UNITED STATES PATENT AND TRADEMARK OFFICE

| APPLICATION NO. | FILING DATE | FIRST NAMED INVENTOR | ATTORNEY DOCKET NO. | CONFIRMATION NO. |
|-----------------|-------------|----------------------|---------------------|------------------|
| 10/630,443 | 07/30/2003 | Jerry E. Bandstra | 2-5169-049 | 9315 |

| Office Action Summary | Application No. | Applicant(s) | |

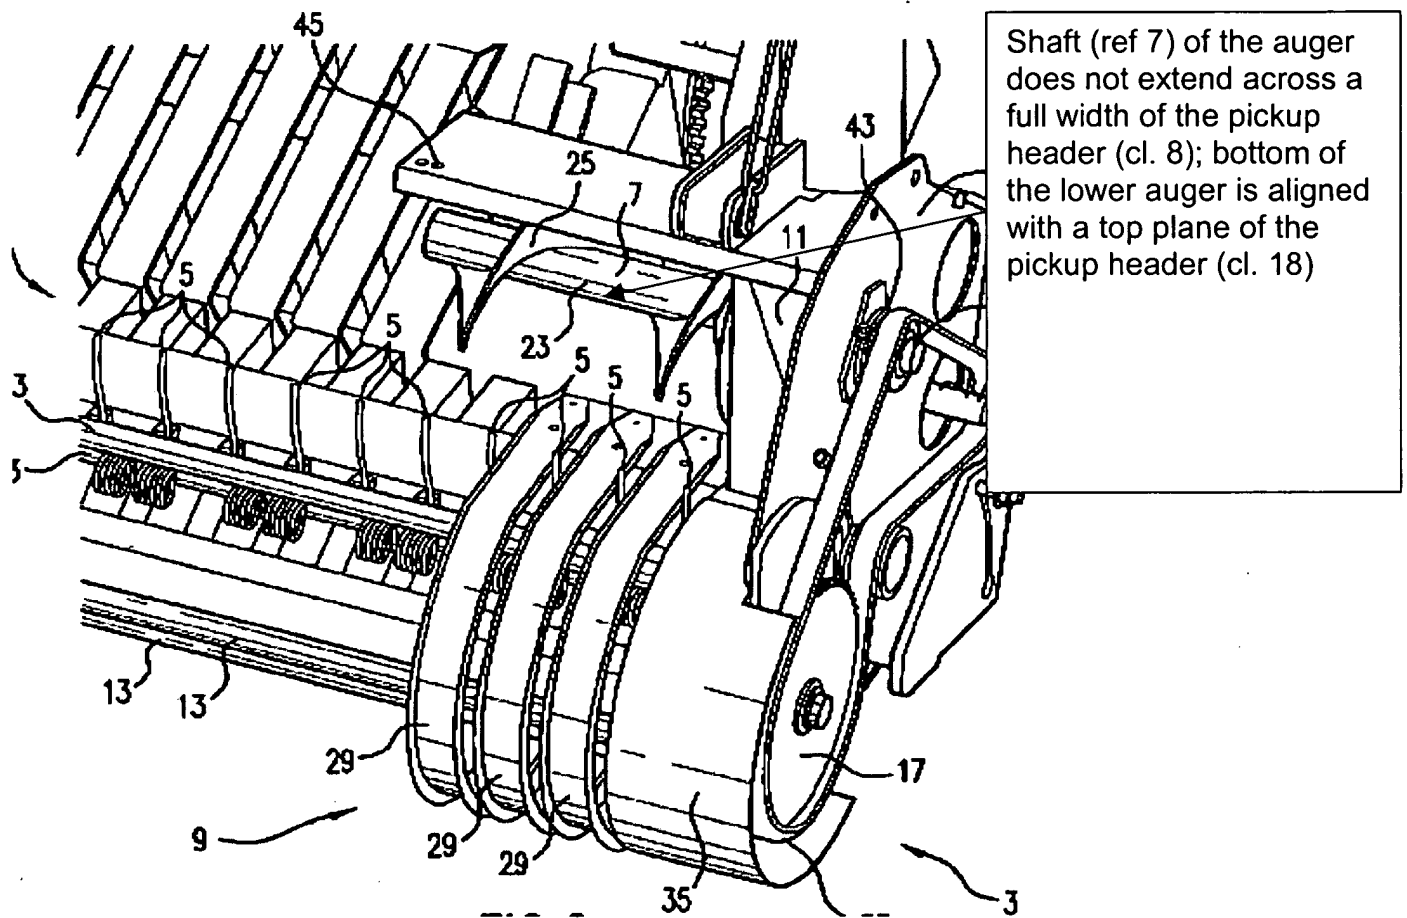
In re claim 8. An apparatus for crop processing having a processing width defined by a distance between a left side and a right side of a processing unit, the apparatus comprising:

a pickup header that is wider than said processing width (see marked up figure below);

an auger on at least one of a right side and a left side of the

pickup header to move crop material laterally (see marked up fig below).

McClure discloses the claimed invention except for duplicating the right or left augers as claimed.

It would have been obvious to one having ordinary skill in the art at the time the invention was made to have at least 2 augers on top of each other, since it has been held that mere duplication of the essential parts of a device involves only routine skill in the art. *St. Regis Paper Co. v. Bemis Co.*, 193 USPQ 8.

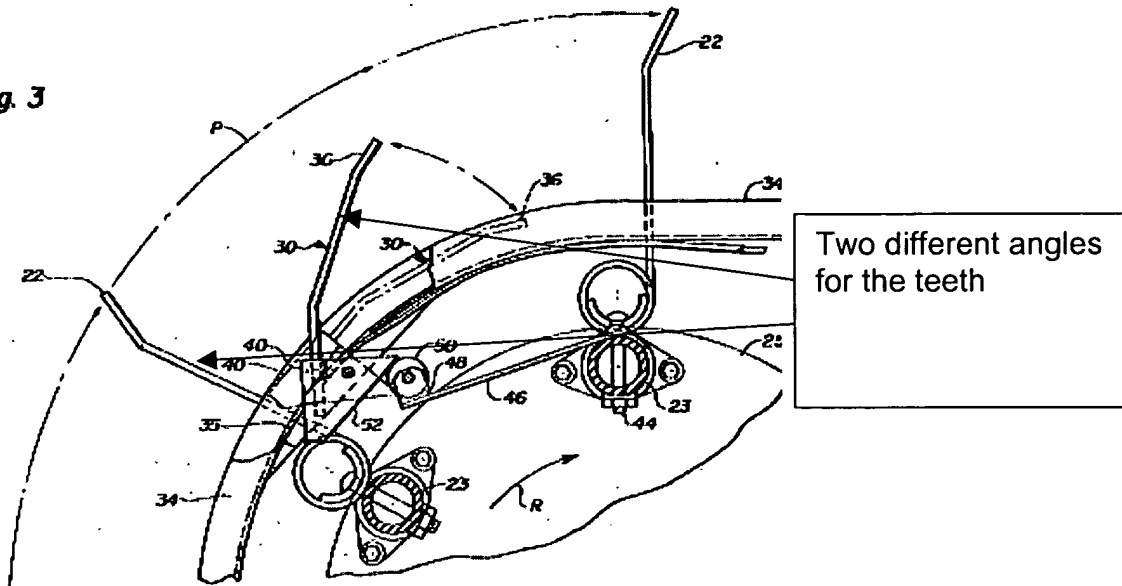
McClure does not provide for rotational speed of the auger as claimed.

In Grahl: as shown in fig 2, pair of augers on at least one of a right & left sides of the pickup header (4 augers are shown, two on each side), which are driven at different rotational speeds (the upper & lower are driven at different speeds; see fig 5, the sprockets are of different size, and their driven in different rotational direction, for these 2 reasons the speeds are different).

It would have been obvious to one having ordinary skill in the art at the time the invention was made to utilize for the duplicate (pair of) augers of McClure different rotational speed as taught by Grahl, in order to increase efficiency.
